CITY OF ALBUQUERQUE

March 27, 2023

Re: Mod Wash
107 & 133 Eubank Blvd. NE
Traffic Circulation Layout
Architect's Stamp 01-27-23 (K20-D060)

OVERALL SITE PLAN

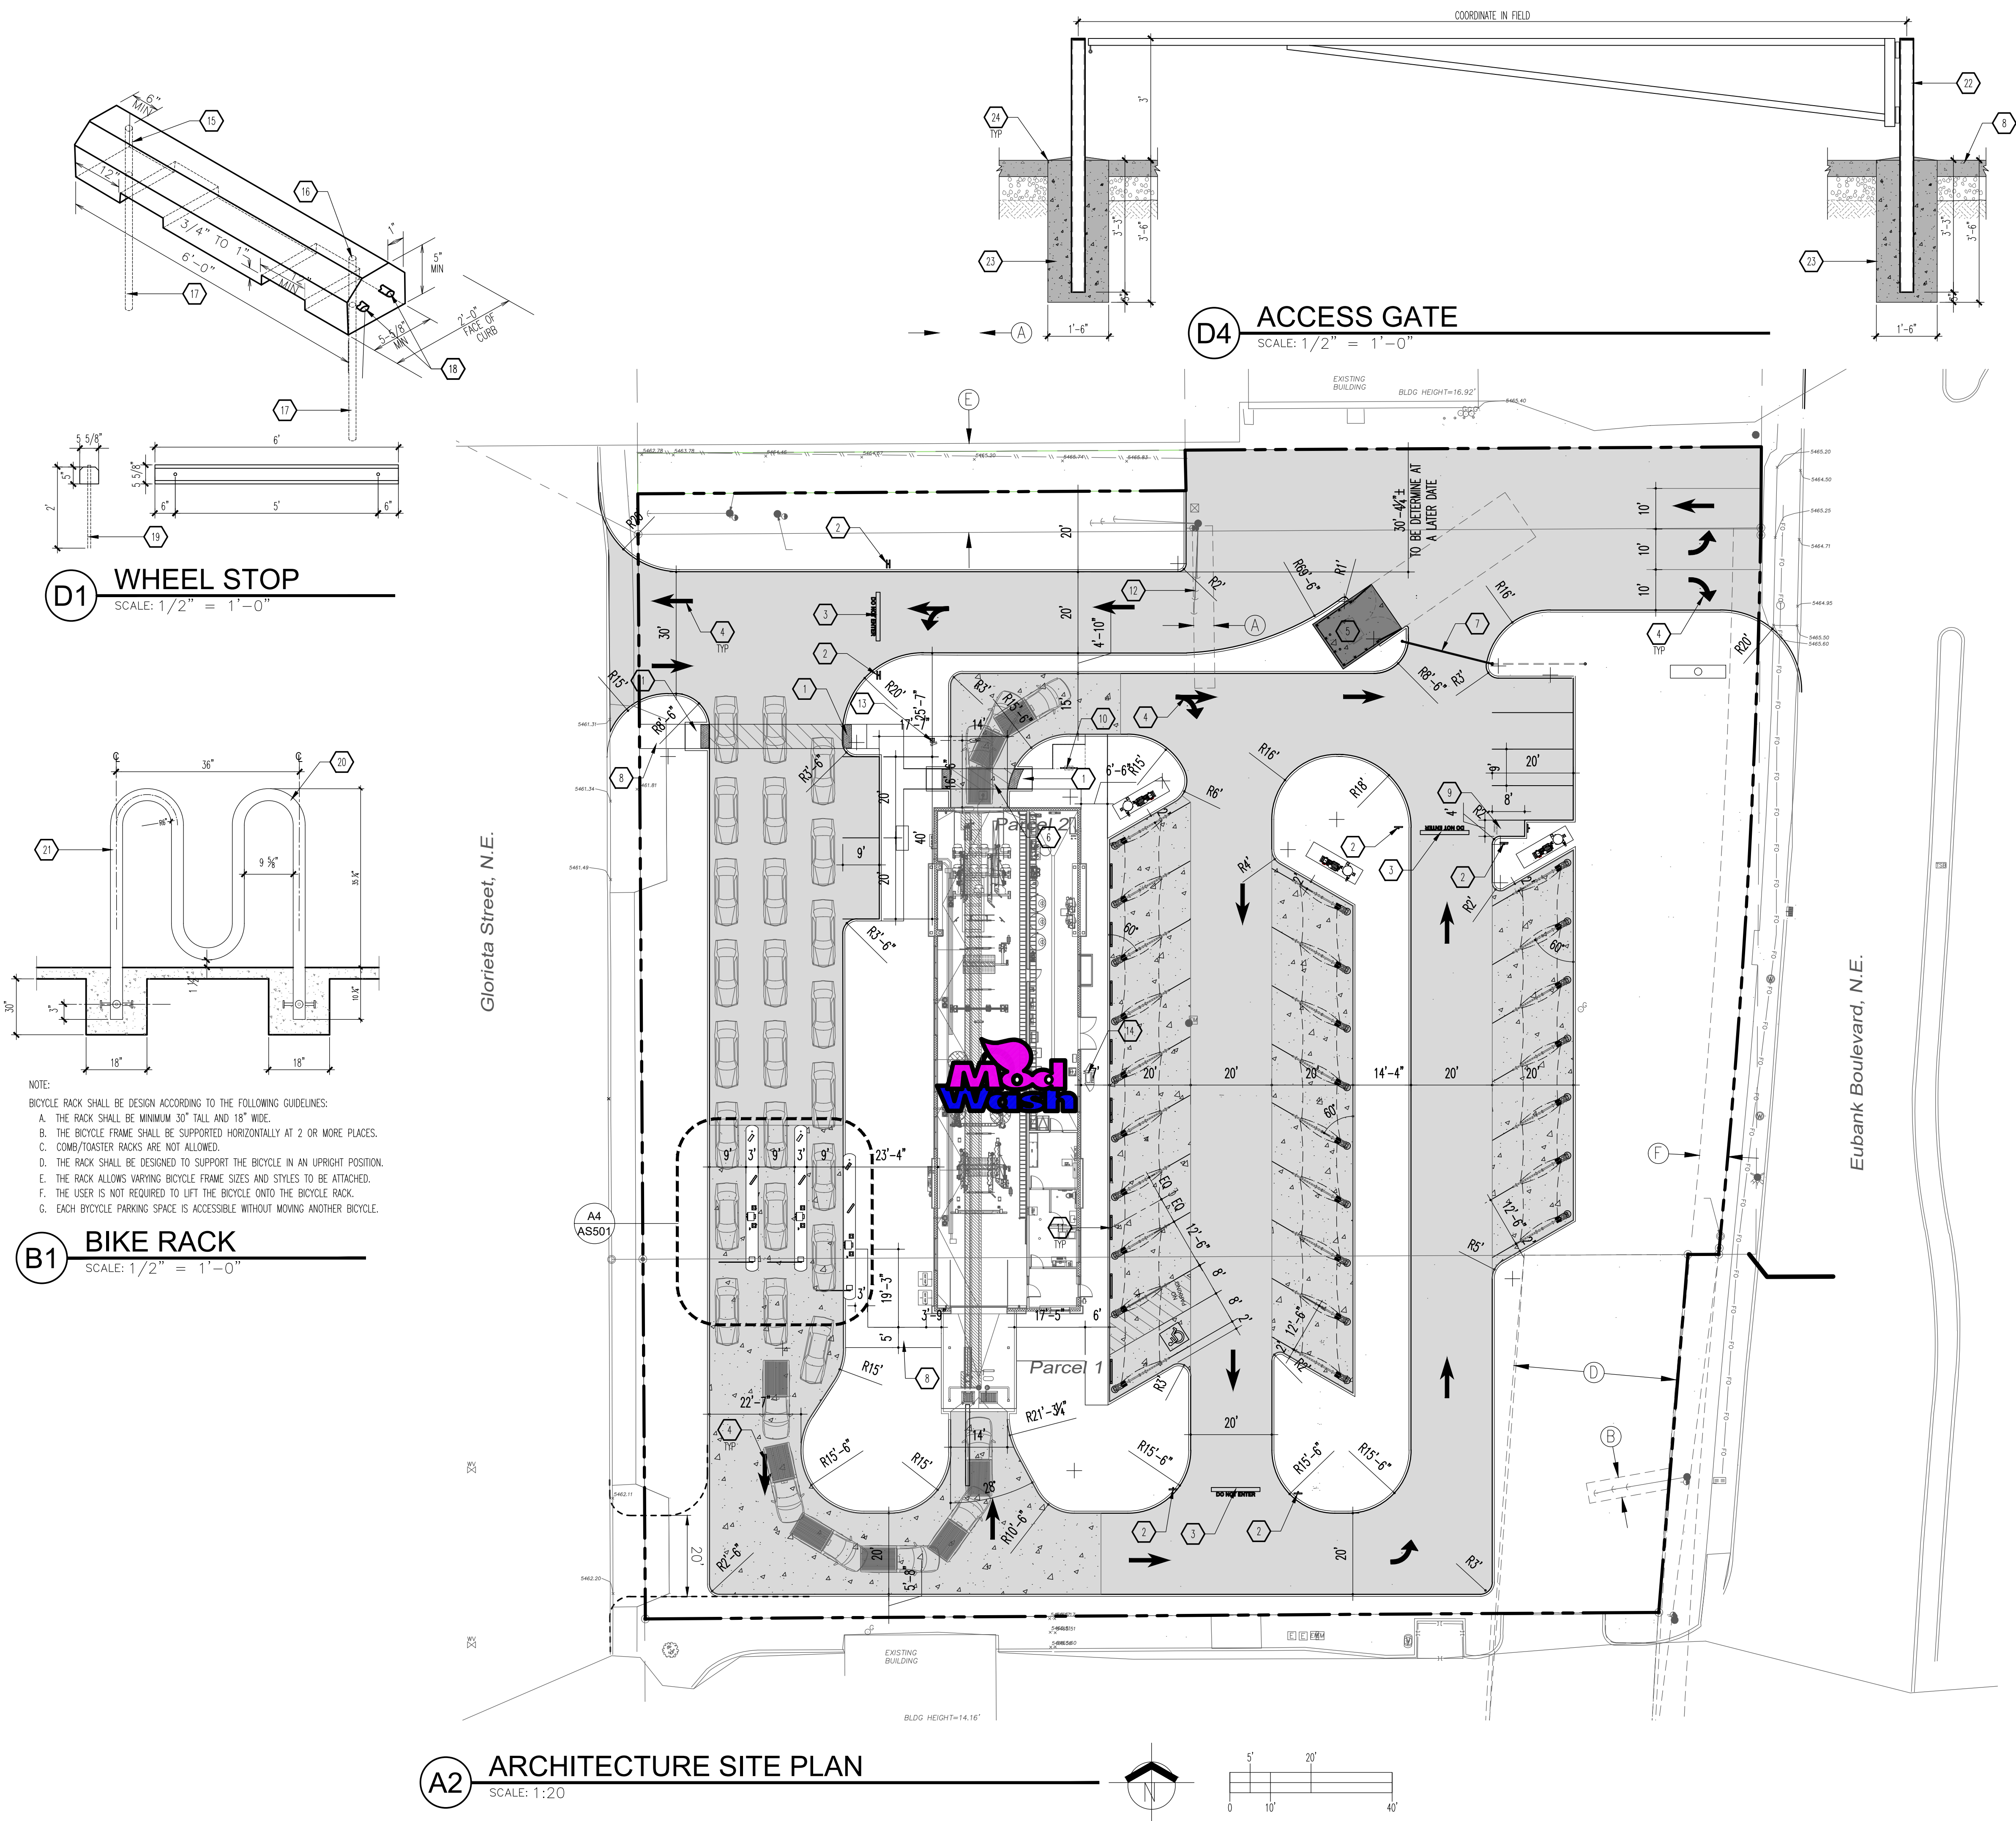
1. Identify the right of way width, medians, curb cuts, and street widths on Eubank Blvd. and Glorieta St.
2. Please provide design details for the access off Eubank Blvd. and Glorieta St., site plan showing proposed radii on the south leg of the access. What about the north part? If you are going to provide a curb return design, an ADA ramp should be provided too. Please address this concern.

3. Provide the width for the existing sidewalks off Eubank and Glorieta St.
4. Please revise the site plan and provide the correct dimensions for the ADA angled parking space. See attached.

7. Ribbon Bike Rack, is no more permitted in new project.
8. 9' wide drive-thru lanes are too tight. Please provide wider lanes.
9. Per the IDO, a 6 ft. wide ADA accessible pedestrian pathway is required from the public sidewalk to the building entrances. Please clearly show this pathway and provide details.

10. Per DPM, a 6 ft. wide ADA accessible pedestrian pathway is required from the ADA parking stall access aisles to the building entrances. Please clearly show this pathway and provide details.

11. ADA accessible pedestrian pathway should not be placed behind parking space or adjacent to a vehicular way. Vehicle and pedestrian/wheel chair conflicts should be avoided as much as possible.

C3 HANDICAP PVMT MARKING
SCALE: 3/4" = 1'-0"

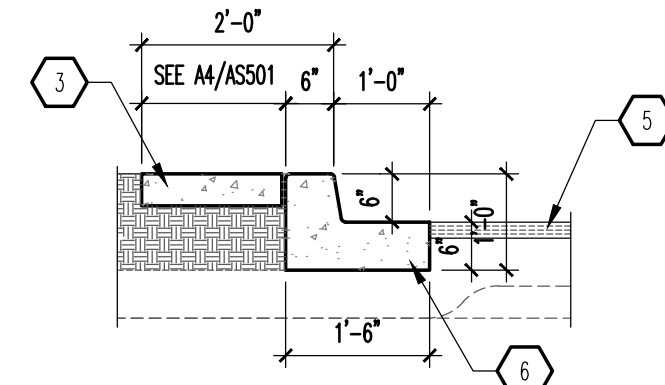
5. Please show ADA sign details on Transportation details sheet, and not on Solid Waste details sheet.
6. Provide Motorcycle parking sign posted upright, either free-standing or wall mounted per the zoning code.
